# Rezoning Transportation Analysis

Petition Number: 2020-038

General Location Identifier: Tax ID 20143102

## Revision Log:

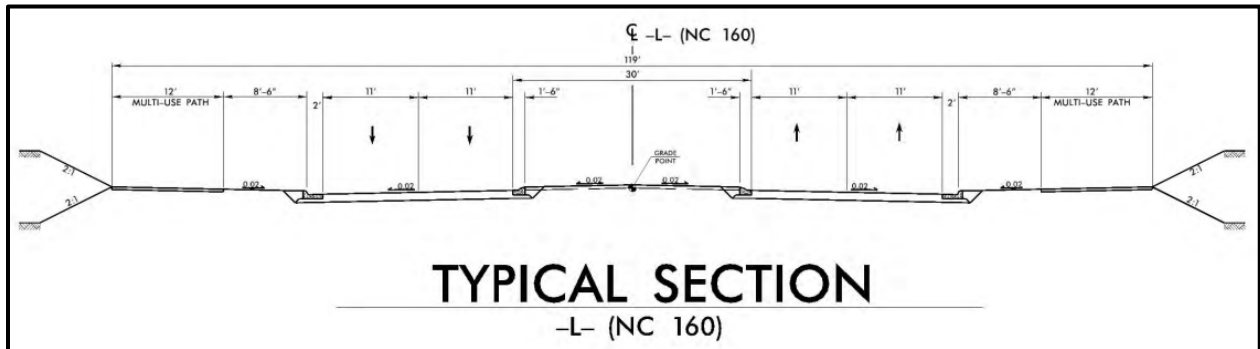
1. **Curbline** The proposed zoning district has a setback measured from back of the existing or proposed future curbline.

- a. **Steele Creek Road:** Location of curb and gutter needs to be shown on the plans based on the NCDOT TIP Project (U-5766) NC 160. The curb and gutter doesn't need to be constructed, but it does need to be shown on the plans.

The site plan should show the curb and gutter labeled and dimensioned from the centerline for each road.

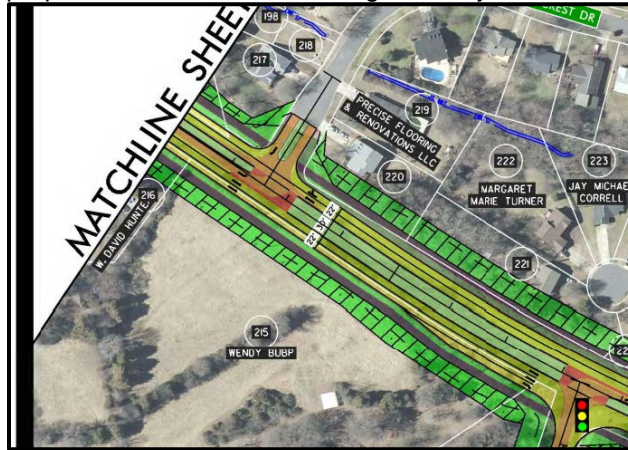
- a. **New Comment based on revised site plan dated 4-1-2020:** Please review the NC 160 cross section provided below to revise the site plan to include the correct curb line and right-of-way location.

- a. **New Comment based on revised site plan dated 4-1-2020:** Please refer to the cross section below on the NC 160 project's Map 4 at <https://www.ncdot.gov/news/public-meetings/Pages/U-5766-2019-08-21.aspx>. This resource will provide more guidance to

properly revise the driveway stem to provide 50' from the future right-of-way line. The driveway should be perpendicular with the future right-of-way.
